M12780 - In the Matter of EfficiencyOne's (E1) 2027–2031 Demand Side Management
(DSM) Resource Plan Application

1 **Request IR-1:**

2 **Reference: E-23, Page 8, lines 6-11.**

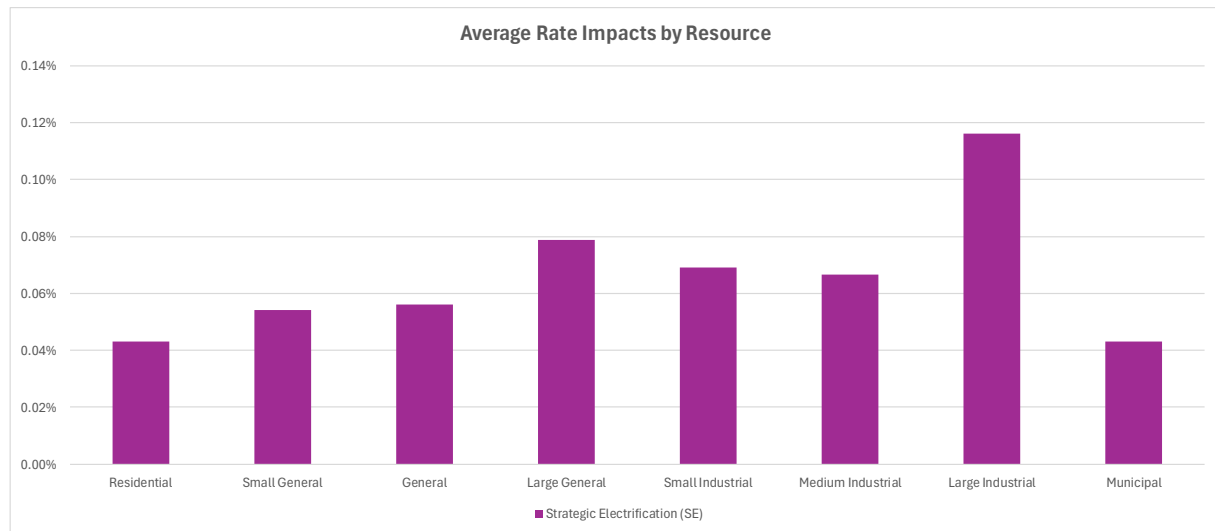
2 (a) Did Synapse conduct a RBIA for the Round 2 SE results? If so, please
3 provide the disaggregated rate class impacts. If not, please explain why
4 not.

10 (a) Synapse did not conduct a RBIA for the Round 2 SE results. However, E1
11 conducted a RBIA for the Round 2 SE results and provided this RBIA in
12 response to Synapse IR-02 as Attachment 2, Appendix K: RBIA Round 2
13 – Scenario Comparisons. I provide a snapshot of the disaggregated
14 average rate impacts by rate class from this workbook in the table and
15 figure below.

Average Rate Impacts								
	Residential	Small General	General	Large General	Small Industrial	Medium Industrial	Large Industrial	Municipal
Strategic Electrification (SE)	0.04%	0.05%	0.06%	0.08%	0.07%	0.07%	0.12%	0.04%
